**MEMORANDUM**

DATE: 06/04/2020  
TO: Application File G-18620  
FROM: Phillip Marcy  
SUBJECT: Changes in proposed POA locations

## Groundwater Application Review Summary Form

Application # G- 18620

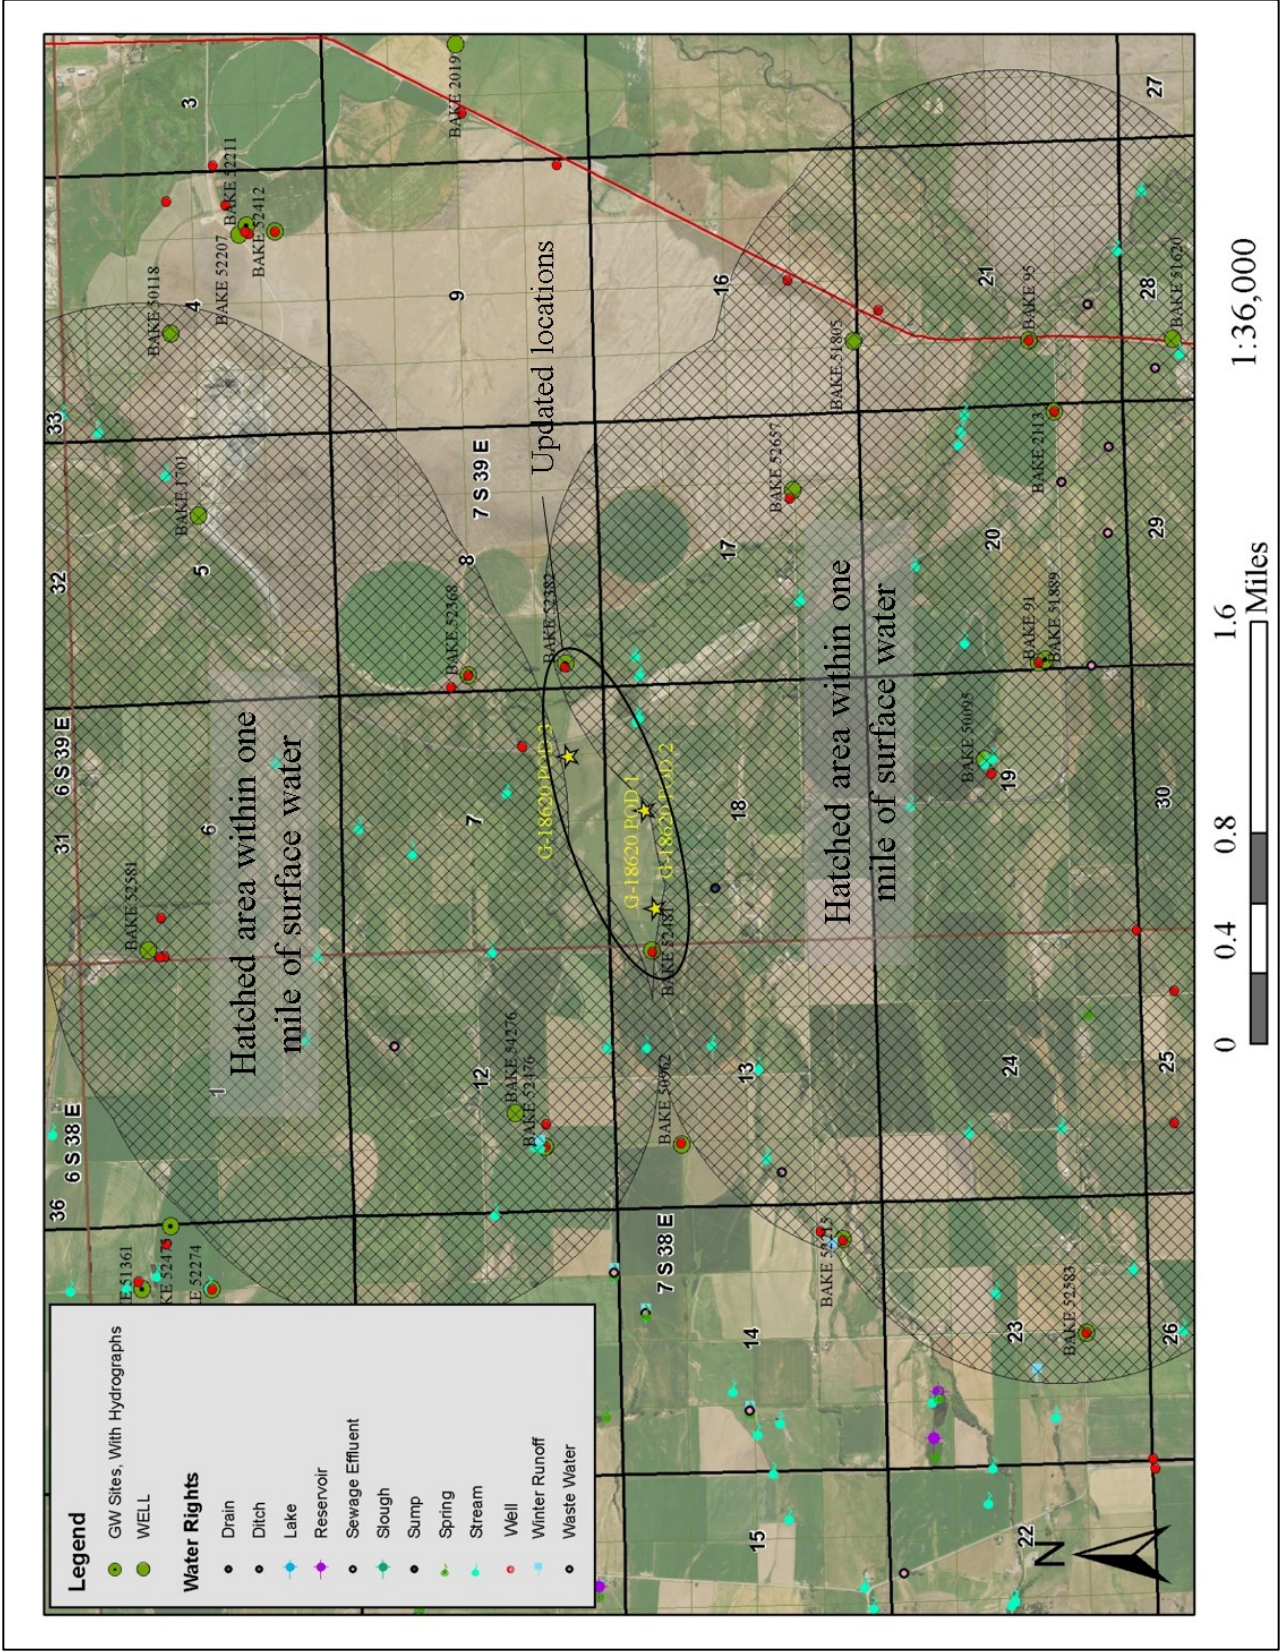
This memo addresses proposed changes in POA locations for Wells 1, 2, and 3 on application G-18620, for John and Zach Wilson. In the groundwater review dated 11/13/2018, PSI was triggered with nearby surface water for all three POA locations, based upon establishment of hydraulic connection to these streams and their location less than one mile from perennial surface water. In the updated map submitted by the CWRE, metes and bounds locations place all three POA locations outside of one mile from nearby surface water sources (see attached map), therefore rendering the finding of PSI with surface water no longer valid.

Water-Level Trends in Nearby Wells

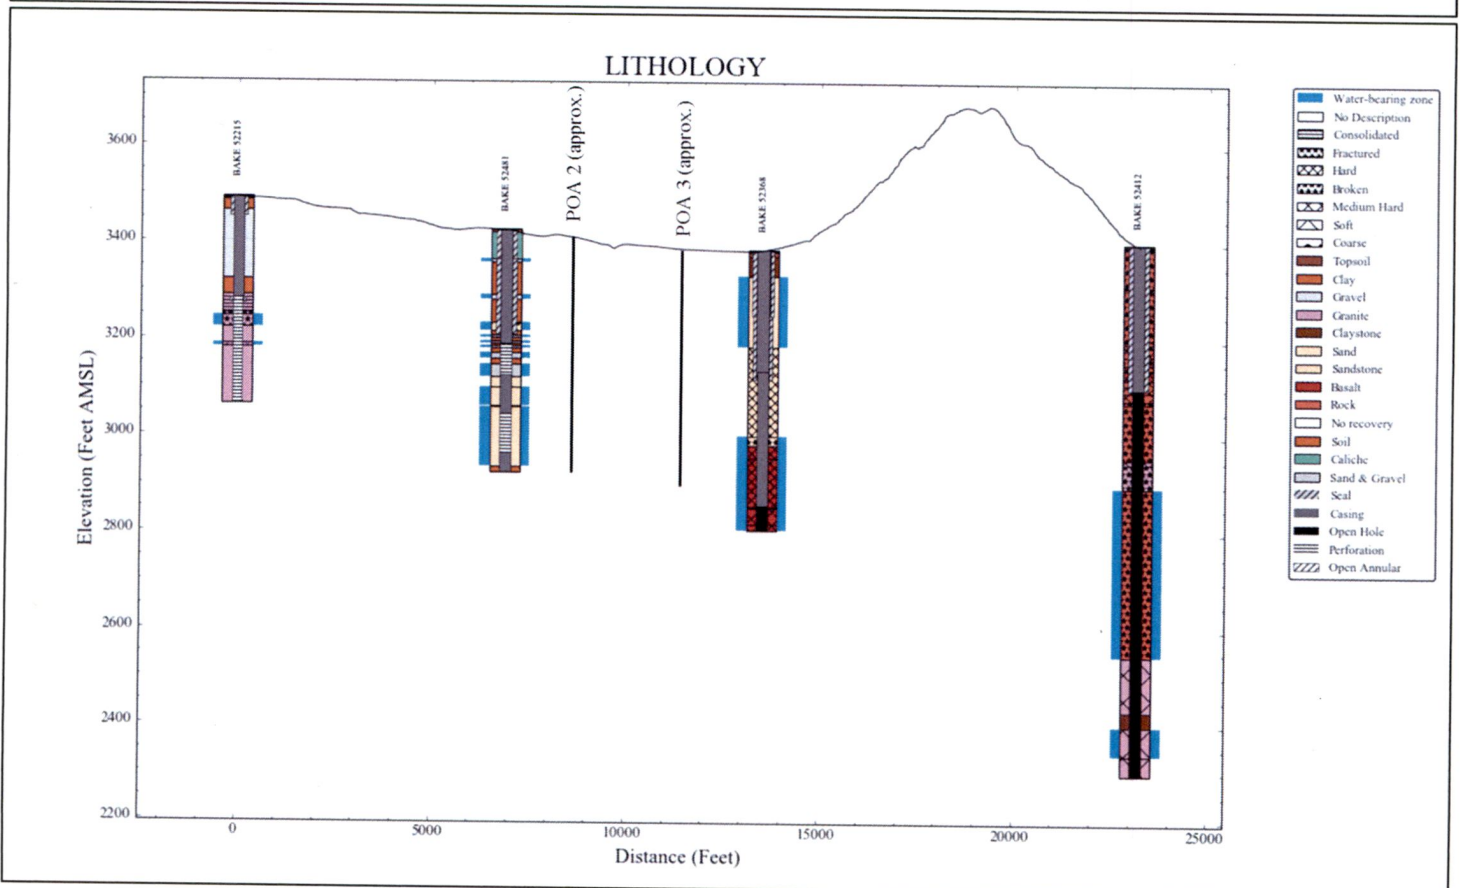
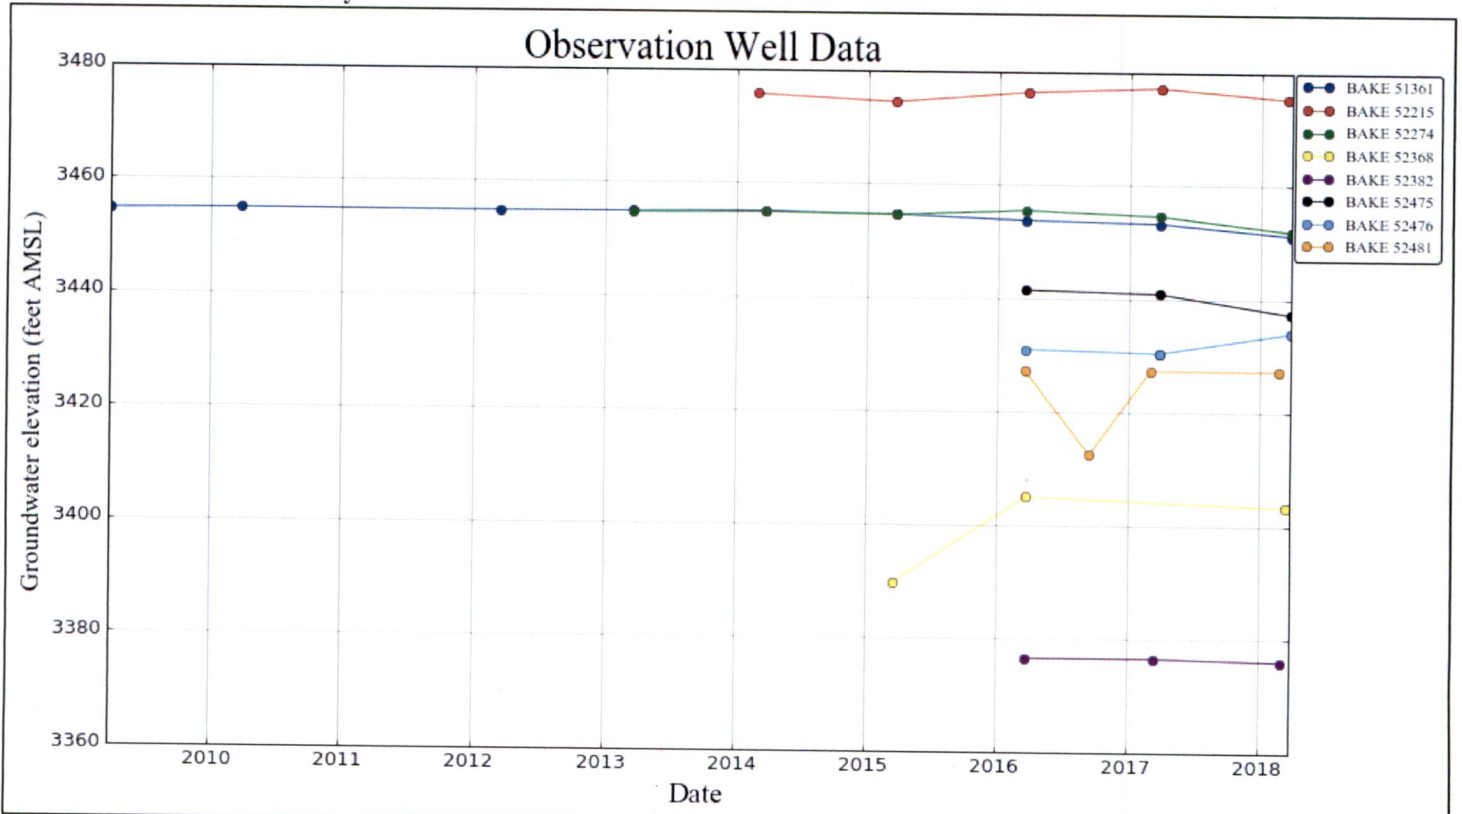
B3. **Groundwater availability remarks:** Expected seasonal drawdown at the nearest neighboring well (BAKE 52481) with similar construction was computed to fall within the range of less than 2 feet, to roughly 150 feet within a pumping season. This assumes the full-time use of the proposed POA well closest to neighboring wells for the duration of the proposed pumping season at the maximum pumping rate. The most likely scenario, using transmissivity from a pump test performed on BAKE 52481 (T2, S2 in the attached model run output), resulted in a predicted seasonal drawdown of 21 feet. The Theis time drawdown model was utilized for these calculations, with parameter values determined by the well log and pump test data for nearby BAKE 52481, which the proposed POA construction appears to be based upon.
